Siemens SQN70 Actuating Damper Motor

Printed in USA 6/21 Form No. 62280-001 R1

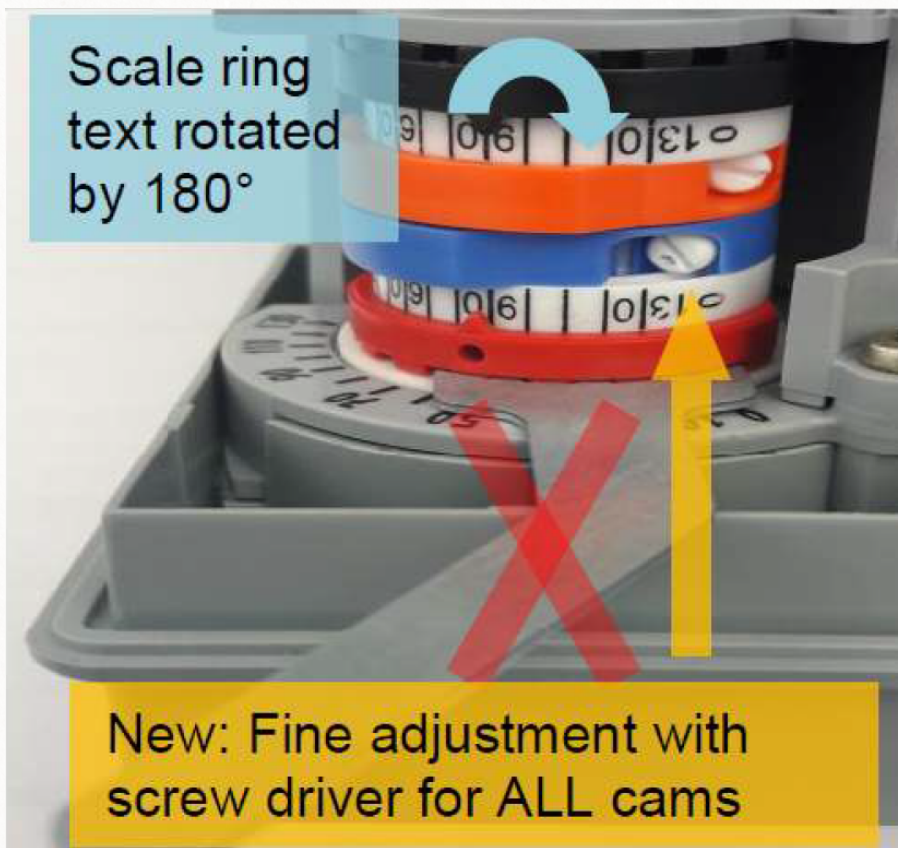
All models of SQN70 and SQN71 actuators produced after April 1, 2021 have fine adjustment switch cams which are easily adjusted with a standard, flat blade screwdriver (not included). Every single cam is now adjusted using a screwdriver. Previously, some SQN7 switches may be adjusted coarsely via a lever tool which is no longer possible. The adjustment is now easier and more accurate with a screwdriver.

The color, wiring and functionality of the cams has not changed.
